IMPORTANT SAFETY RECALL

Subject: NHTSA Campaign Number 19E-072

Models Affected: Hendrickson CONNEX ST trailer steerable suspension and axle systems with

PRODUCT BULLETIN – IDENTIFYING MOUNTING WASHER

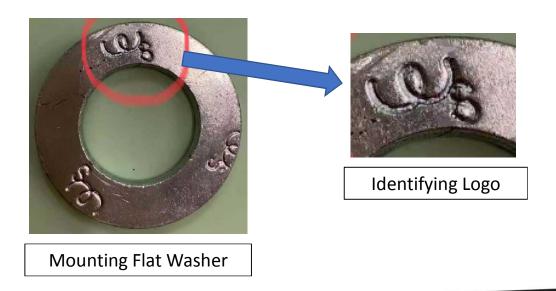
- This bulletin covers how to identify washers that may not conform to TSE's hardware specifications.
 - 1. Mounting Flat Washer with stamped logos (as pictured) may have compromised material properties. TSE recommends replacing the washer. Washers can be obtained from TSE free of charge.
 - 2. Washers without logos are not affected and can be used normally.
 - 3. Please reference TSE Brakes TSB#2019-001 for the proper procedure to replace washers.
